Subject: FFTF Comments on Integrated Assessment
Date: Wednesday, August 08, 2012 9:45:48 AM
Attachments: [Integrated Assessment, Draft a,FFTF comments.pdf](#)
[Comments on IA - 08-07-12-FFTF.doc](#)

**Guidance for Performing the Integrated
Assessment for Flooding**

DRAFT Interim Staff Guidance

Figure 2: Evaluation flowchart

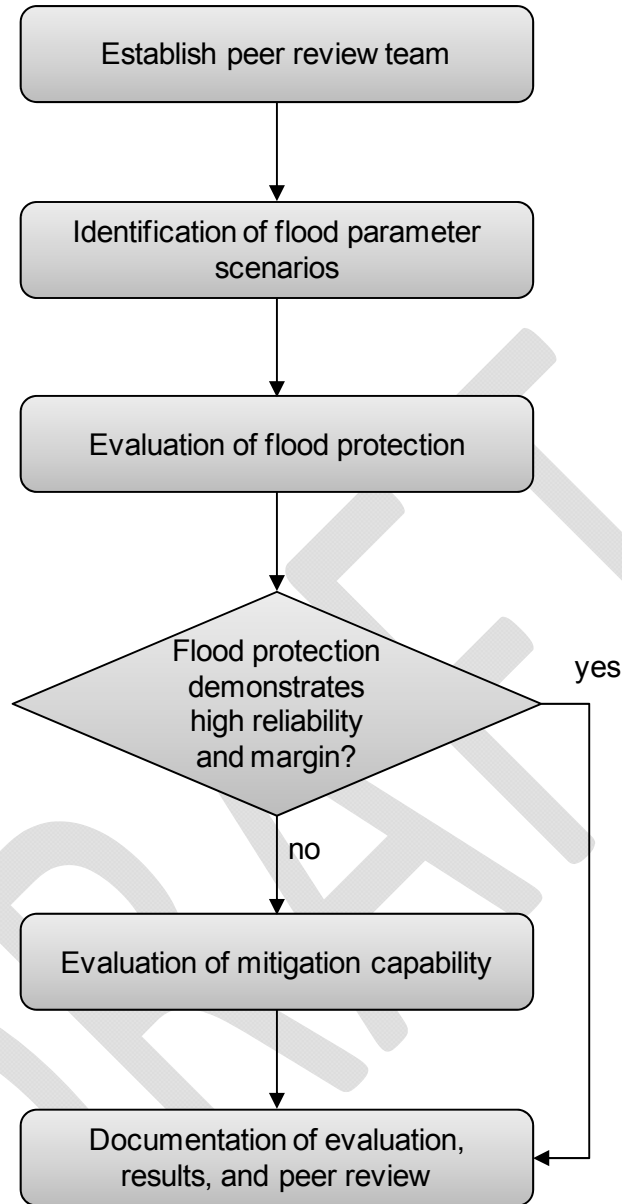
1. assembly of peer review team ← peer review team?
2. determination of controlling flood parameters
3. evaluation of the effectiveness of flood protection systems
4. evaluation of mitigation capability
